ADDENDUM NO. 2

January 11, 2024

Riviera Club Youth Pool and Equipment Building

This Addendum consists of Pages ADD 2-1 – ADD.2-3, Site Logistics Plan and Guideline Schedule, and Schmidt Associates Addendum No. 1 dated January 10, 2024, consisting of 2 pages and Specification Section, 061600 Sheathing, and Revised Addendum Drawings: CG101, CU101, CU501, CE101, CE501, AF1A1, AQ100, AQ200, AQ300, AQ500, and AQ703.

02 WATER FEATURE PIPING DIAGRAM
SCALE: NONE

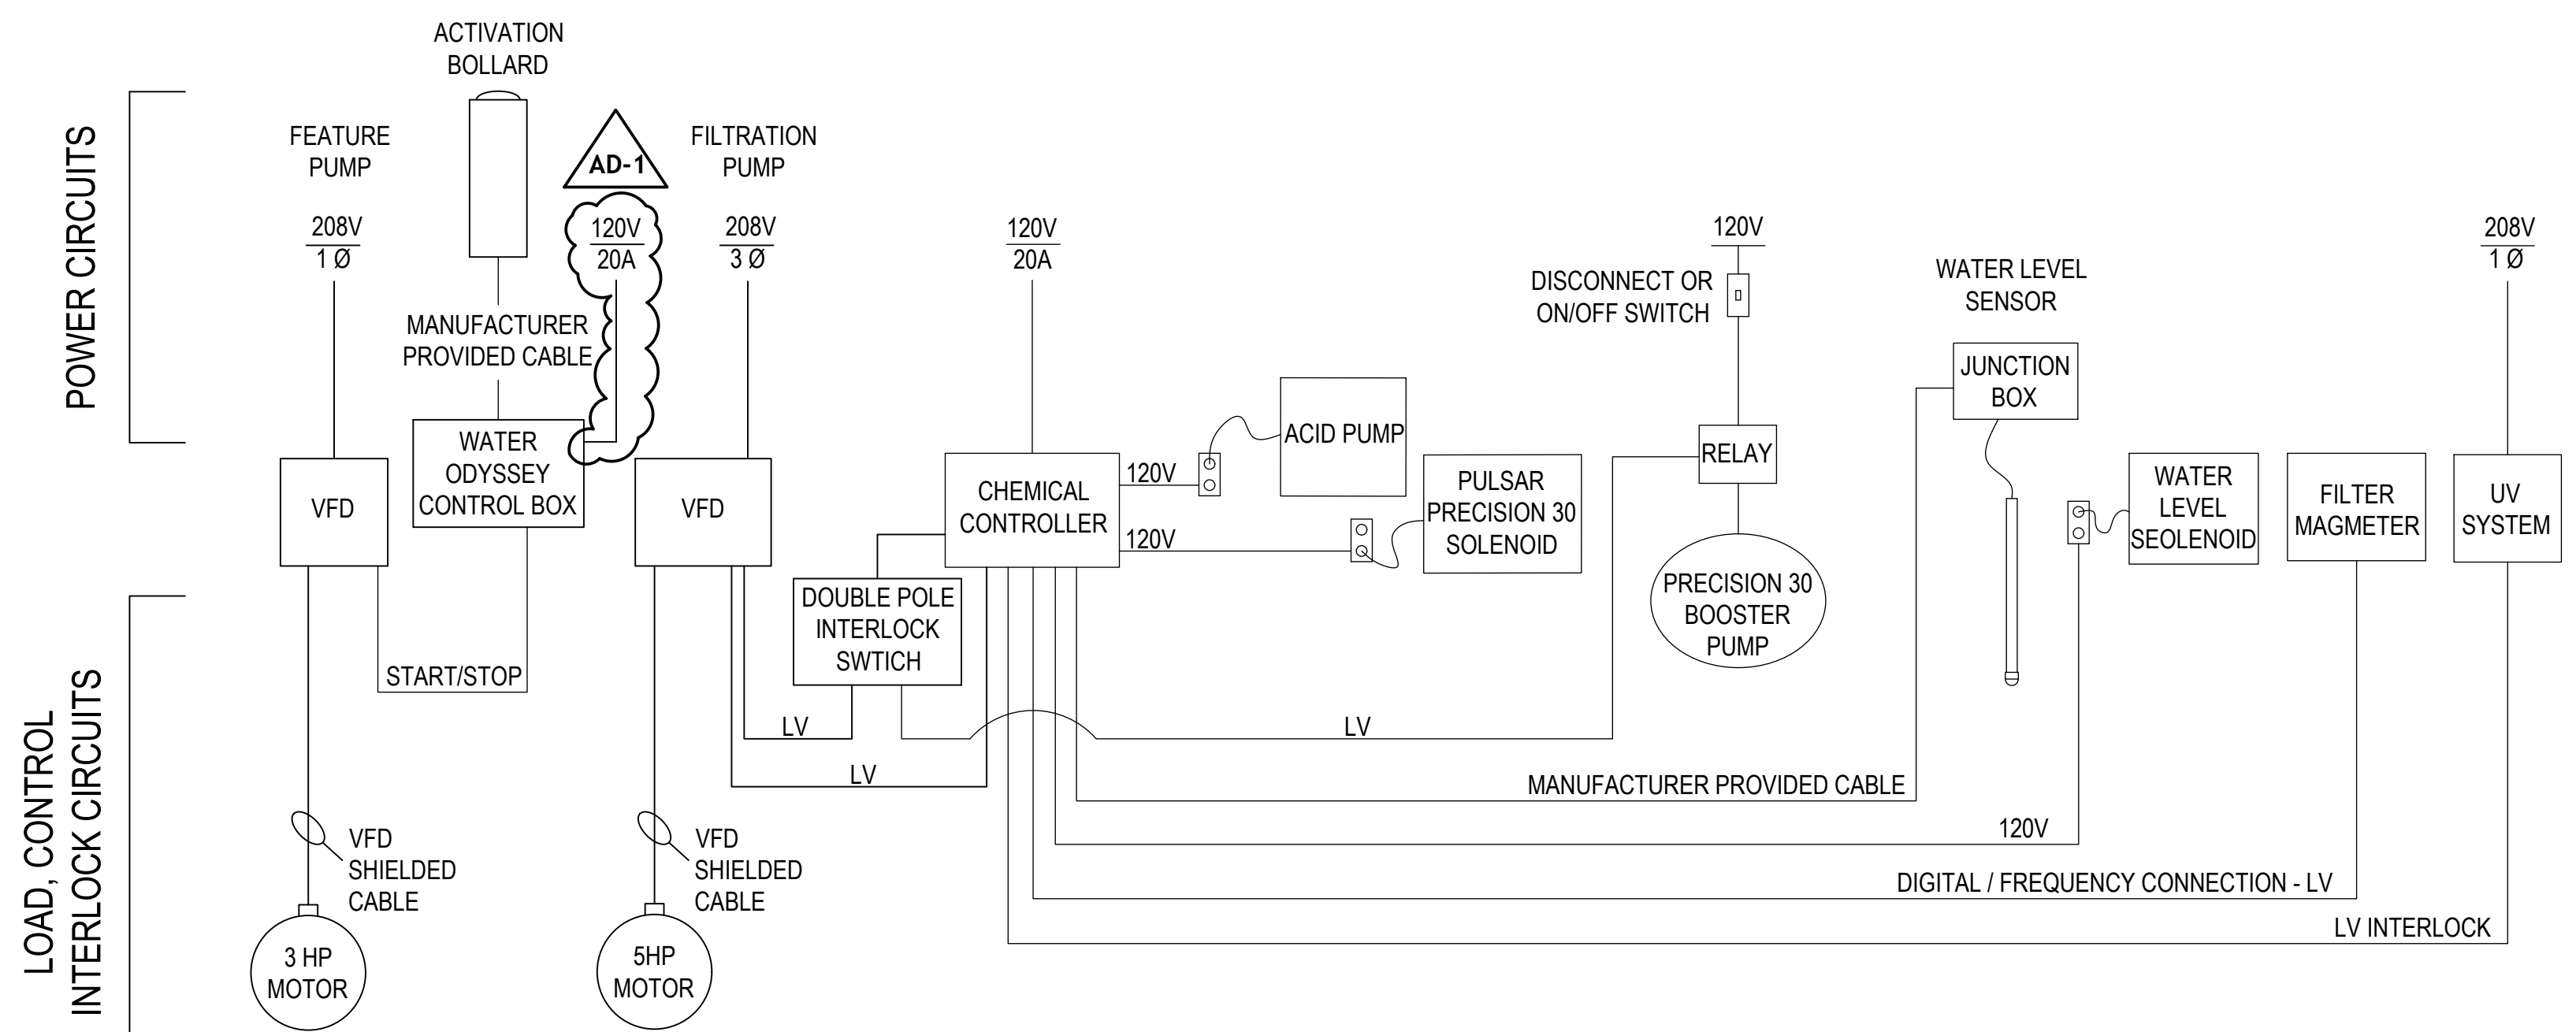
#	Revision	Date
AD-1	ADDENDUM #1: ADDED LOCATION OF ITEM 26 ON DETAIL 02. ADDED CONTROLLER VOLTAGE ON DETAIL 03.	01/10/24
